August 8, 2022

**Caivan (Orleans Village 2) Ltd.**  
2934 Baseline Road, Suite 302  
Ottawa, ON K2H 1B2

Re: Environmental Noise Addendum Letter  
Orleans Village (Phase 4), Ottawa  
GW File No.: GW22-078 – Addendum Letter

**FIGURE 4: DAYTIME STATIONARY NOISE CONTOURS  
(1.5 M ABOVE GRADE)**

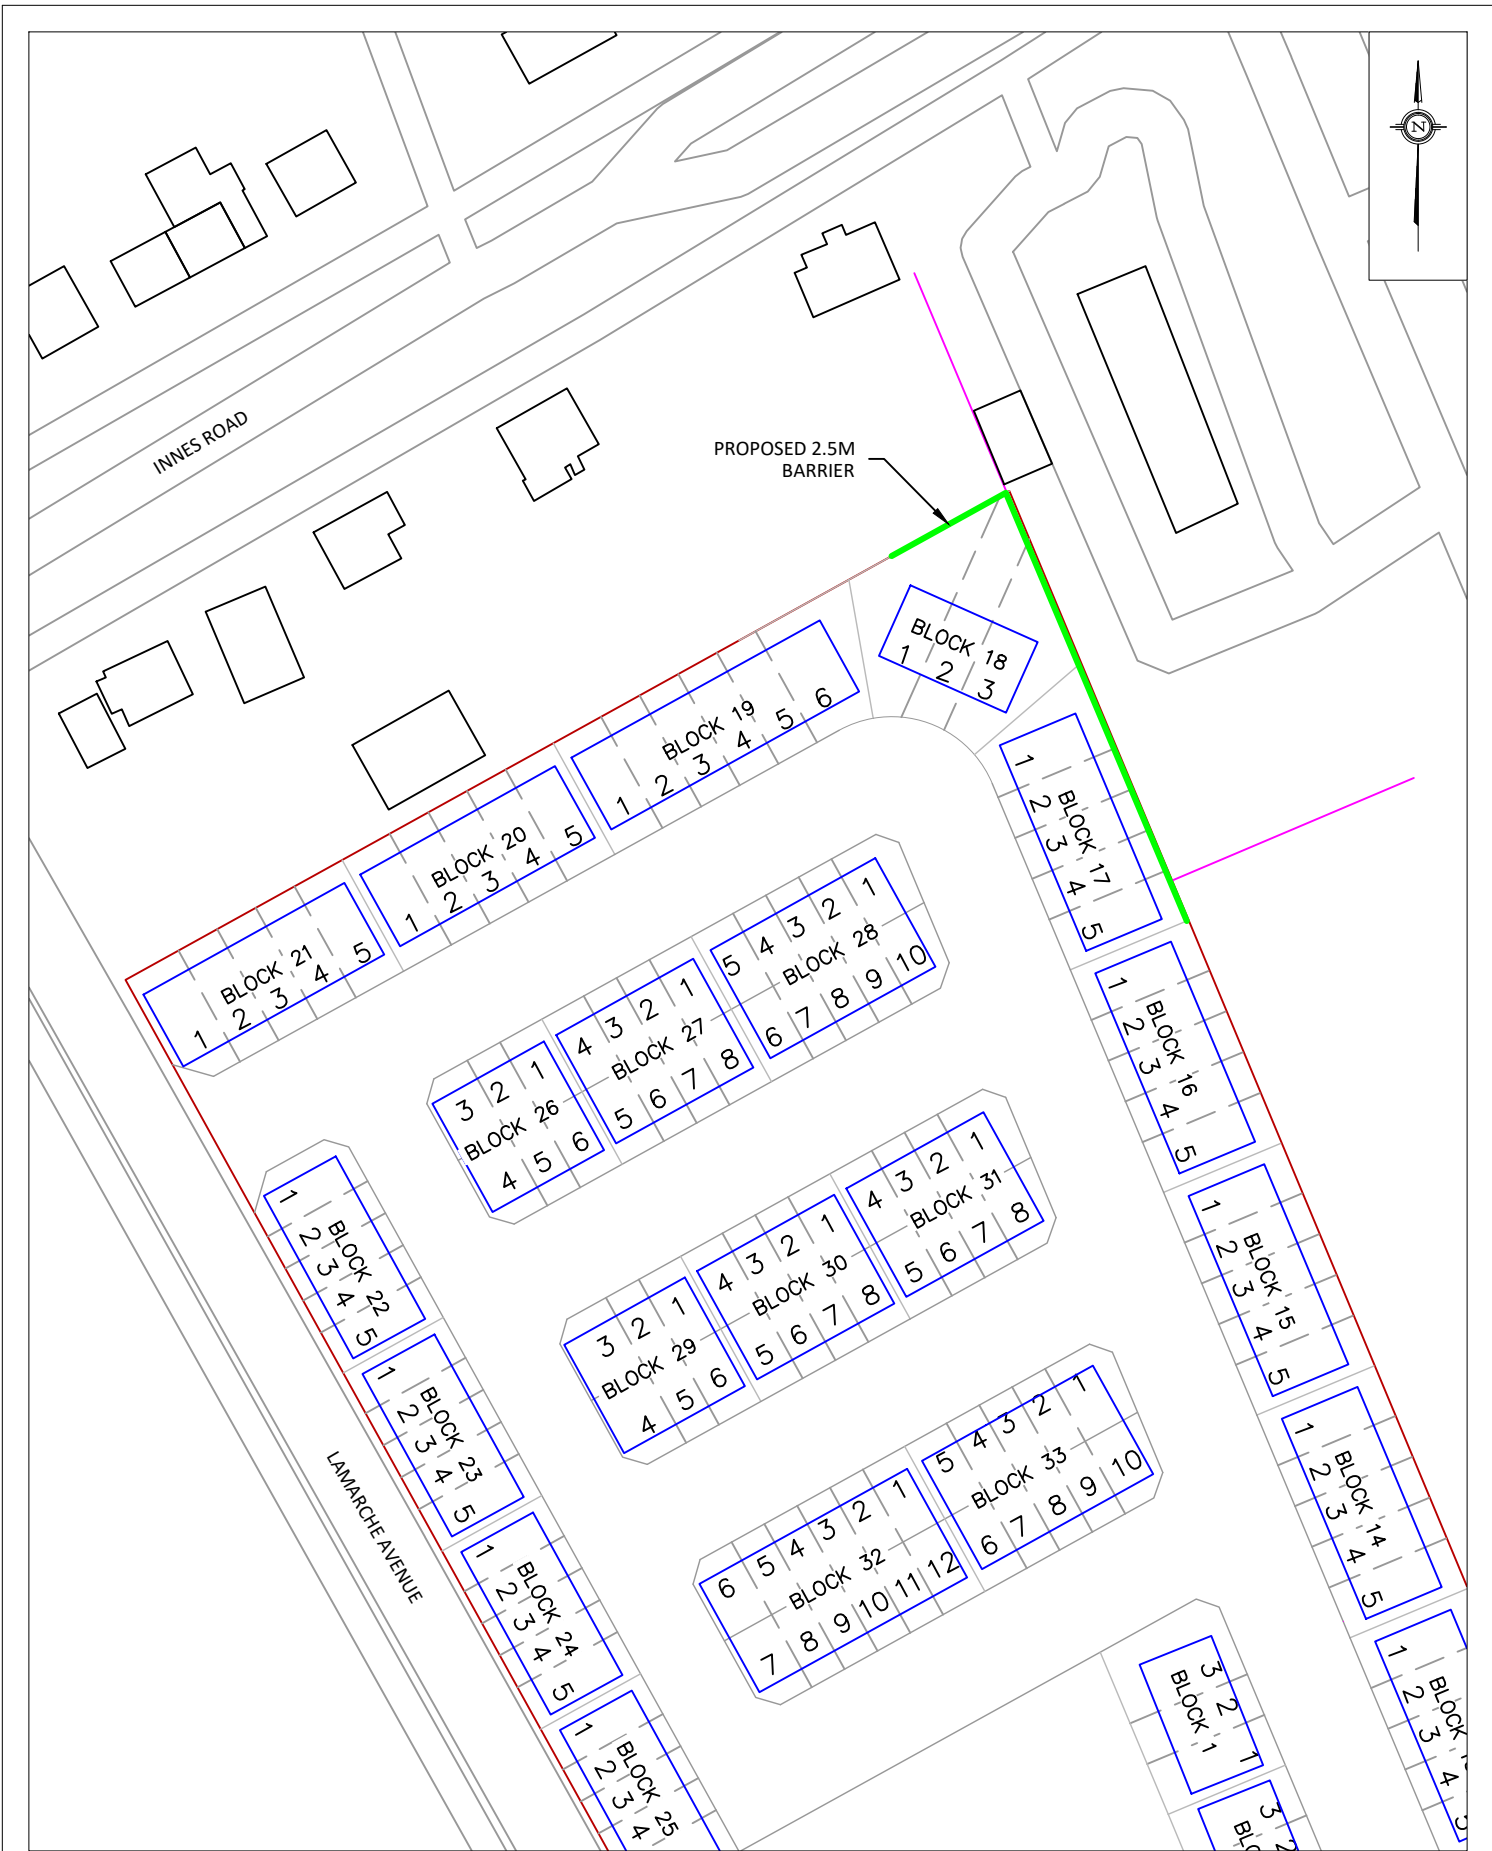
- 1. The noise study identified a 5m tall berm + noise barrier was required based upon the proposed site layout. Consideration should be made to:*
  - rearranging the subdivision lands to provide greater setbacks and result in a shorter required noise barrier, and/or;*
  - providing a different product type that would not include OLAs along the affected blocks. Note that it is the City's preference for mitigation measures that reduce the required height of the required noise barrier.*

- 2. Assess the land requirements on site to accommodate the grading of a 2.5m high berm (refer to berm setbacks within the City's Noise Control Guidelines), since the maximum barrier height that is acceptable is 2.5m. Ensure providing required barrier/berm height is feasible within the proposed block size. Alternatively, discuss the need for a retaining wall.*

As per the City's comments, Gradient Wind investigated the noise mitigating effects of implementing a 2.5 m tall noise wall/berm situated at the northeast corner of the property onto the development, primarily the rear yards. Noise receptors and the proposed barrier location are outlined in Figures 2 and 3, respectively. The proposed barrier length was also reduced such that it terminates at the boundary between Blocks 17 and 16.

The result of the current assessment indicates that noise levels can be reduced for a majority of the rear yards with the implementation of a 2.5m tall noise barrier/berm that terminates between Blocks 17 and 16. The rear yard of Block 18 is expected to experience a slight exceedance over the OPOR criterion with the 2.5 m barrier/berm. It should also be noted that the human ear is not able to perceive a difference in noise levels less than or equal to 3 dBA.
